Staff Report to the Zoning Administrator

Application Number: **211316**

Project Description: Proposal to construct an approximately 110 linear foot pin pier retaining wall, on-site with an existing single-family dwelling.

The contour interval is 1 foot.

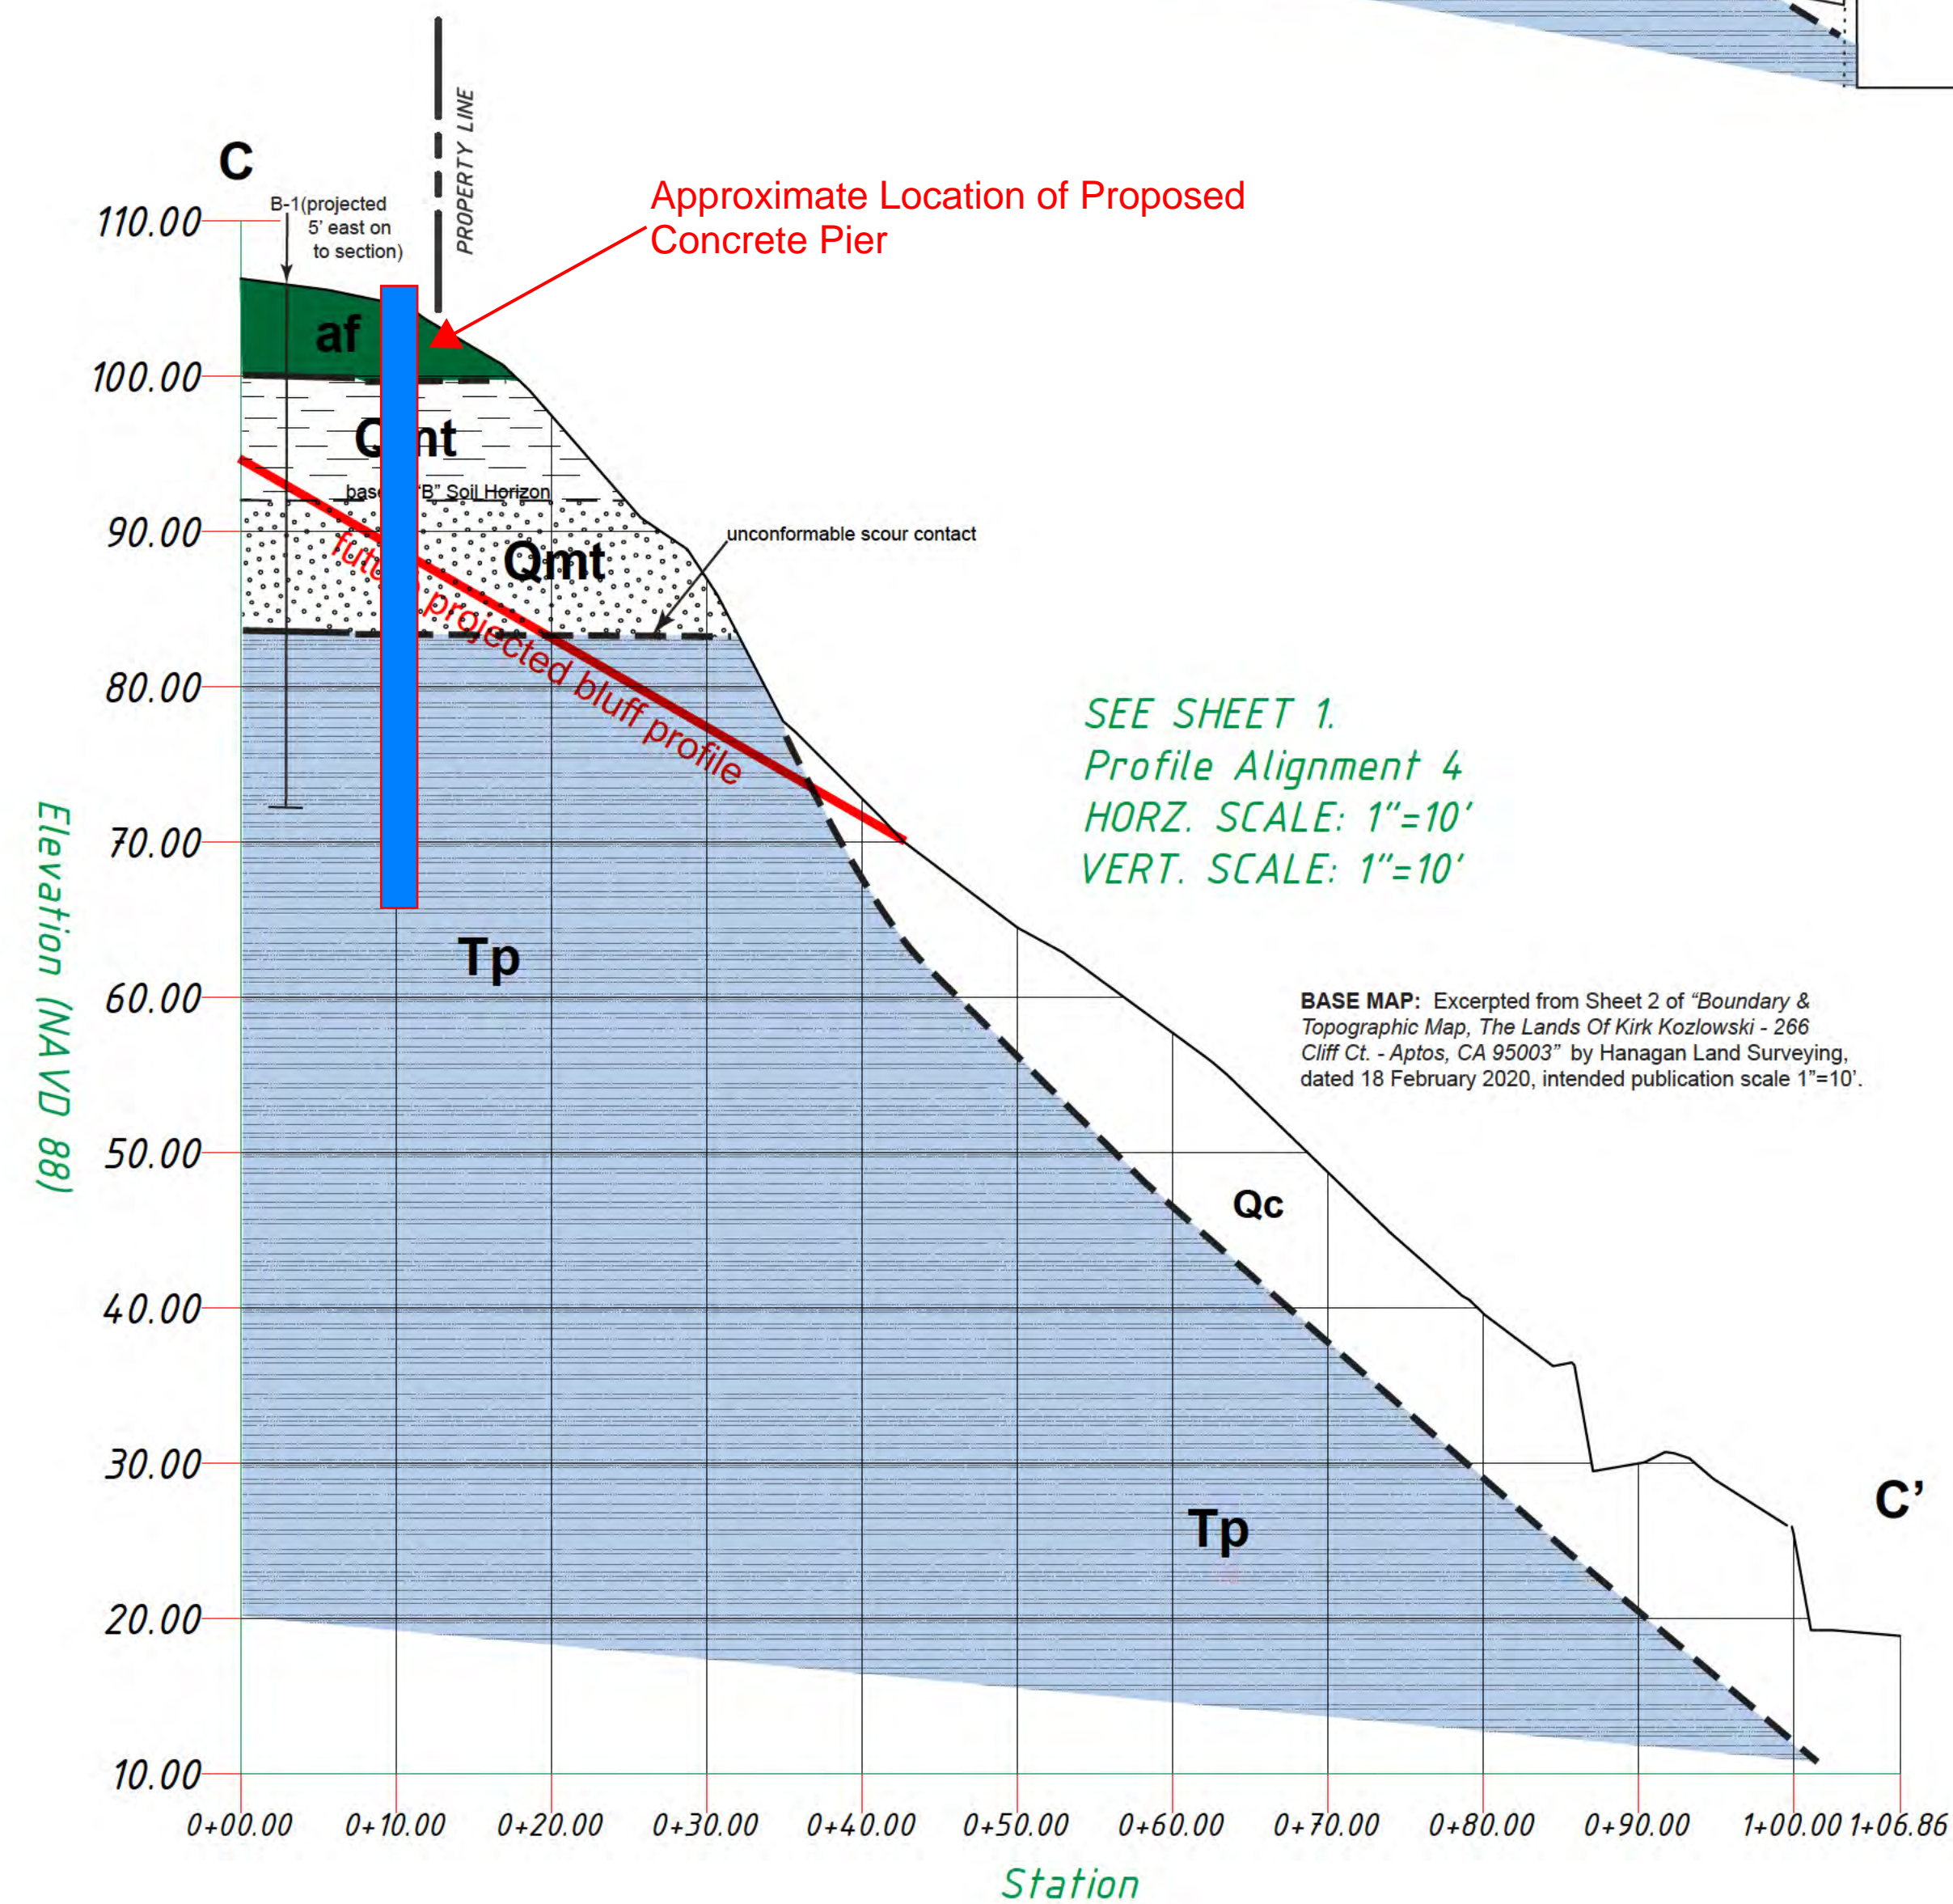
Attachment 3 is a set of geologic cross sections prepared for the project by the applicant’s geologist, Zinn Geology. The geologic cross sections are depictions of what would be seen on a vertical slice through the bluff oriented perpendicular to the bluff face. The approximate location of the proposed retaining structure has been added to the original illustrations. As can be seen from the cross sections, a large amount of soil exists in front of the wall, enough to generate several generations of landsliding of the type observed in 2019 and 2023.
